September 2013 Environmental Update for SLEMA Board

September 30, 2013

Difference in Height (Surveyed Data for the Starter Cell)

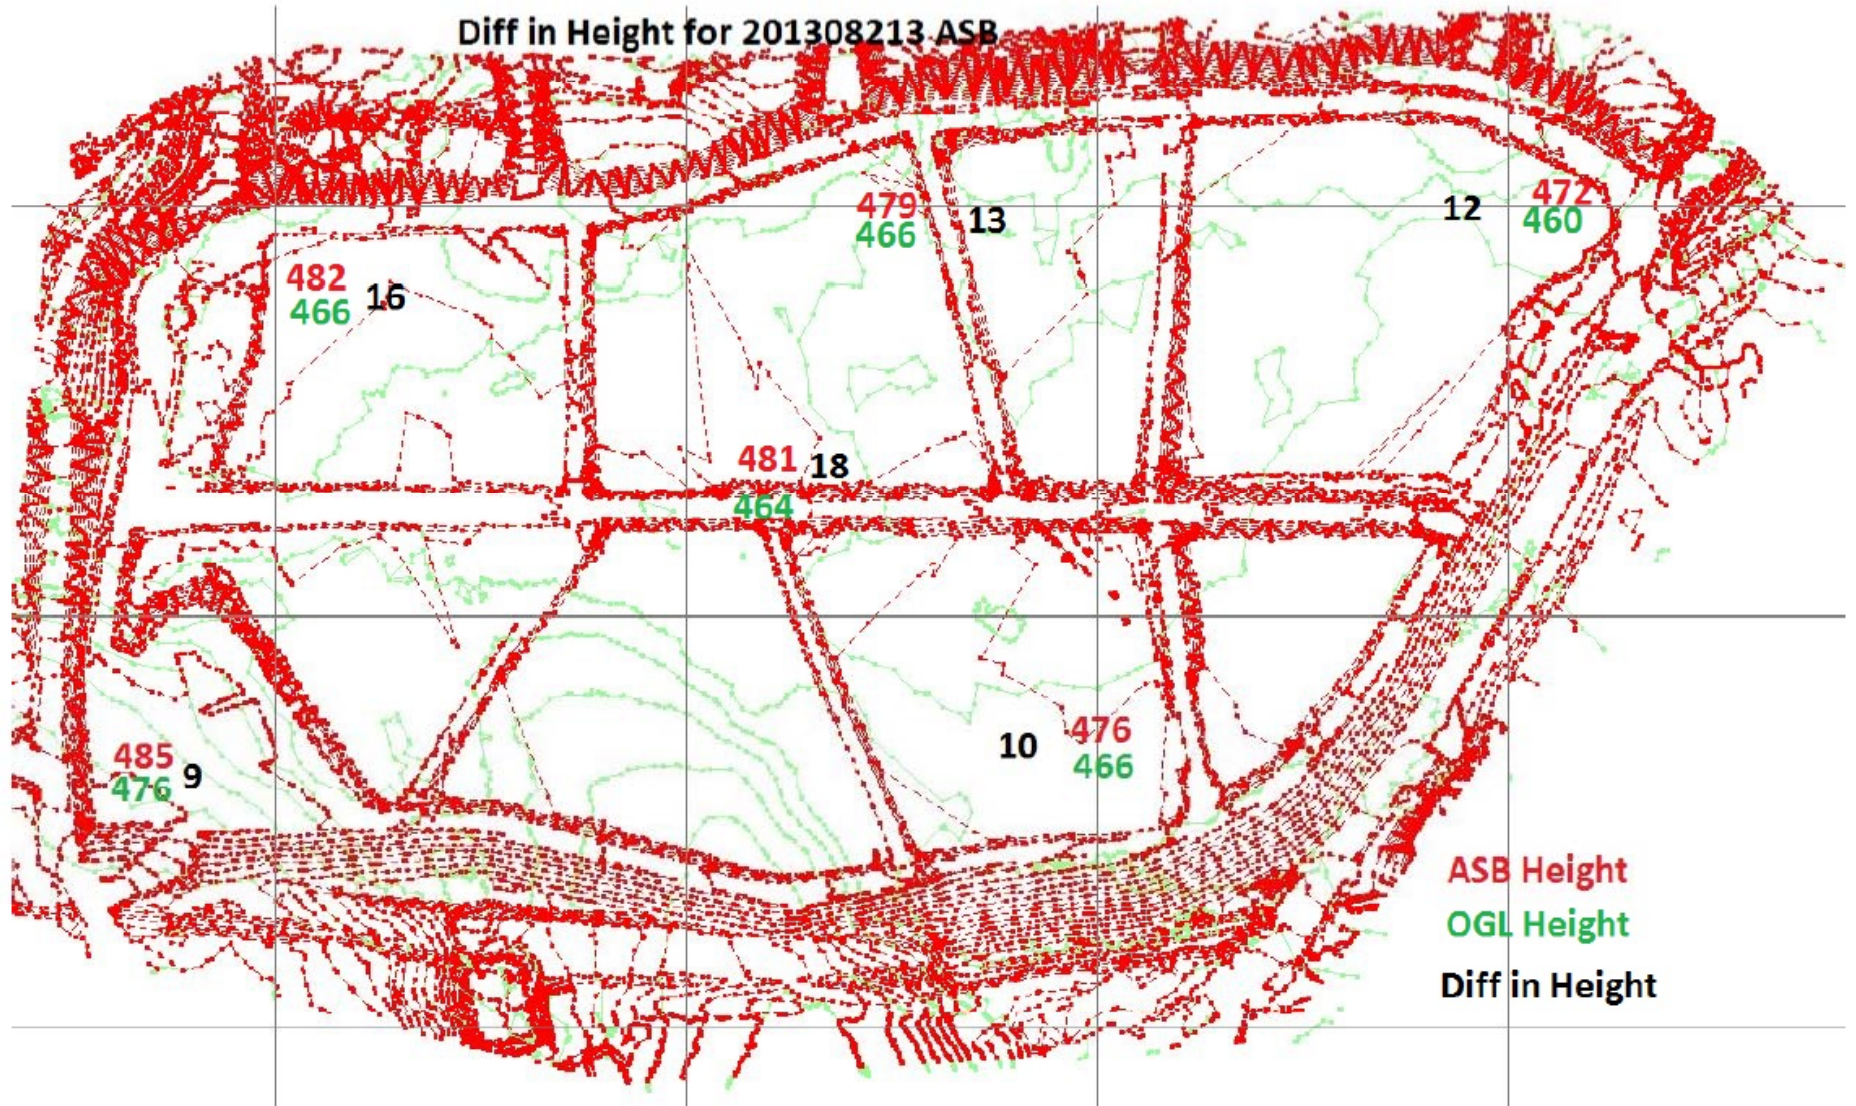
EA Assumption - Ground Level Elevations in North Pile of 450 masl measured from topographic maps not surveyed data (450 masl + 34 m = 484 masl)

Surveyed Data – Ground Level Elevation in North Pile ranges from 460-476 masl

Surveyed Data - Current Heights in North Pile ranges from 9 – 18 m above the Ground Level Elevation

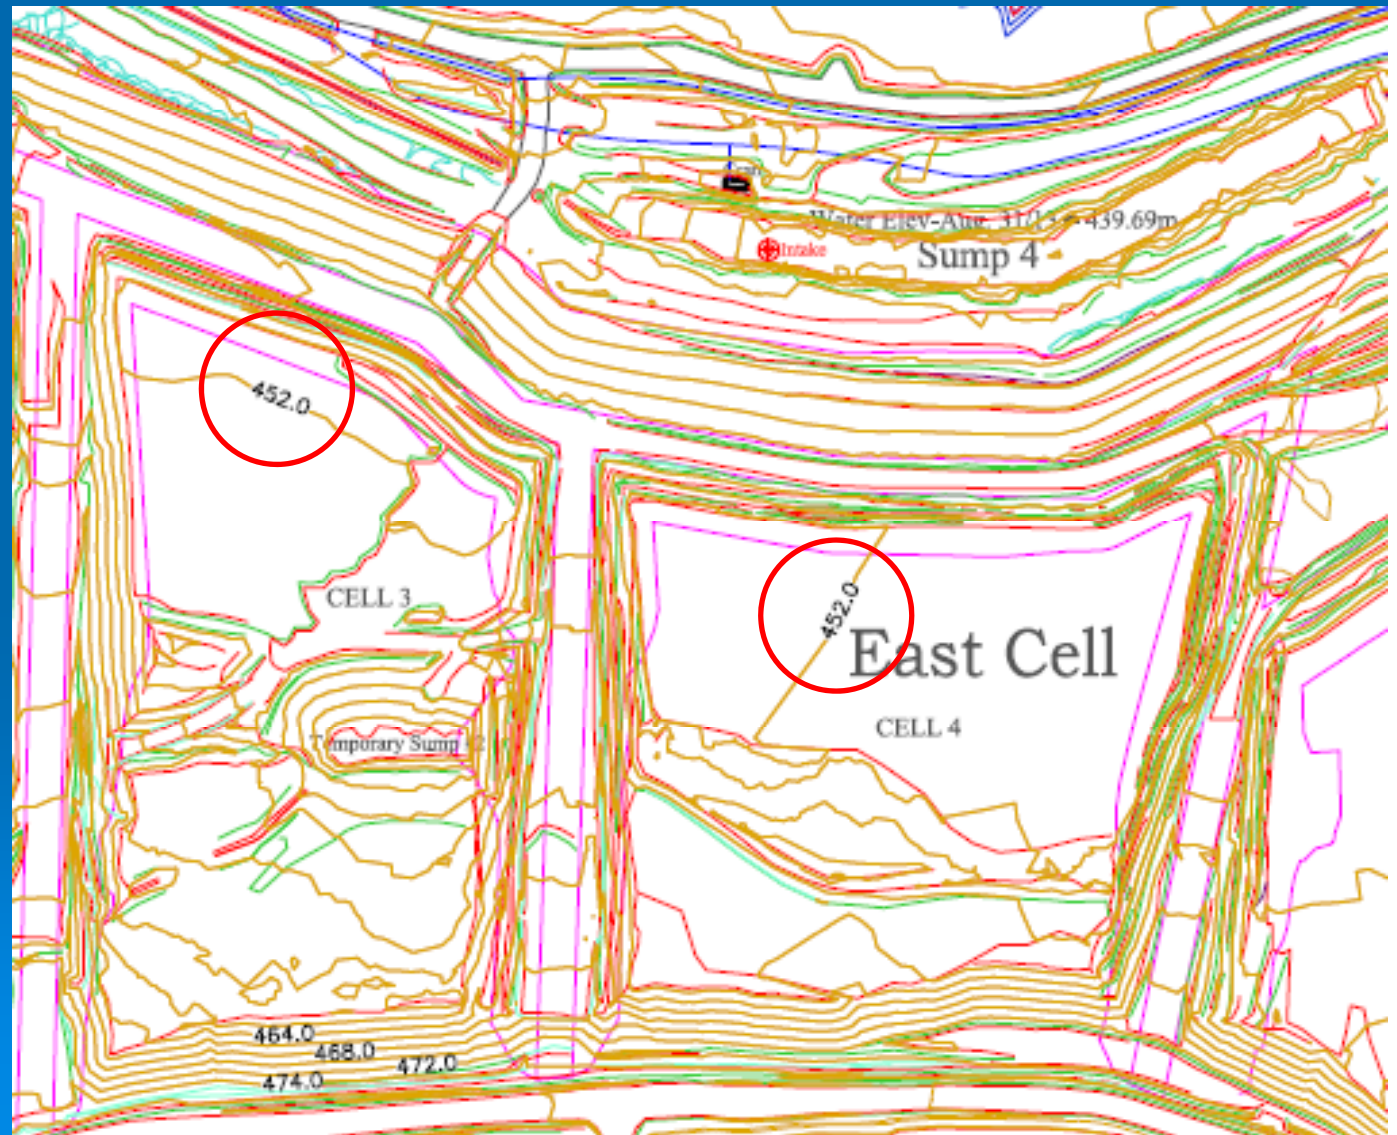
- Via e-mail dated September 9, 2013
 - The statement “Ground Level Elevation in North Pile ranges from 460-476 masl” seems misleading readers. Those data refer to the Starter Cell, the southern part of the North Pile
 - Starter Cell ground level does not represent the ground level of the north Side of the North Pile
 - The ground level elevation in the East Cell should be lower than that in the Starter Cell
